# CR Minimum Cable Assembly and Channel Insertion Loss

Chris DiMinico  
MC Communications/PHY-SI LLC/Panduit  
[cdiminico@ieee.org](mailto:cdiminico@ieee.org)

# IEEE Draft P802.3ck/D1.0

Figure 162A-1—Cable assembly, host, and test fixture insertion loss at 26.56 GHz

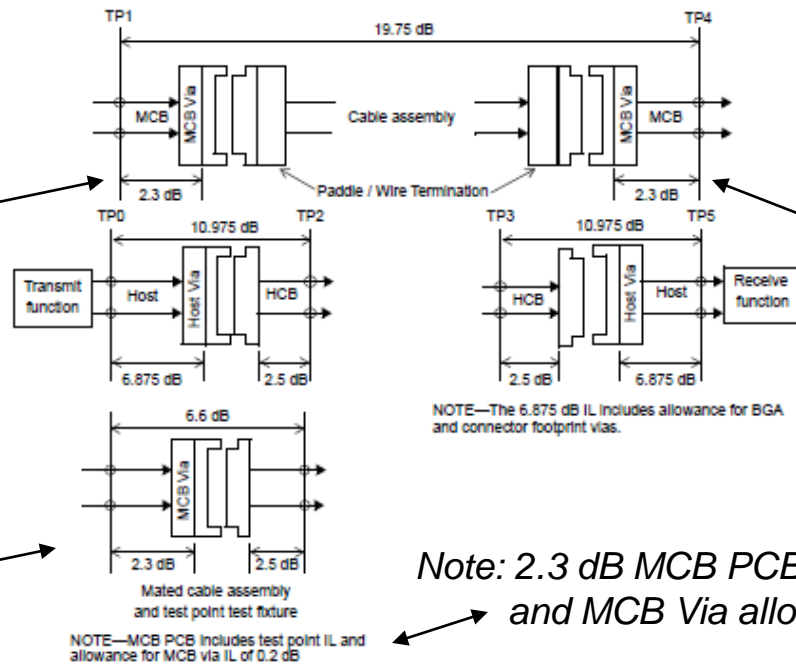
- **CR Minimum Cable Assembly and Channel Insertion Loss**
- **Figure 162A–1—Cable assembly, host, and test fixture insertion loss at 26.56 GHz baseline corrections**

- Move arrows and align text per adopted baseline

- Adopt Min cable assembly = 13 dB @ 26.56 GHz
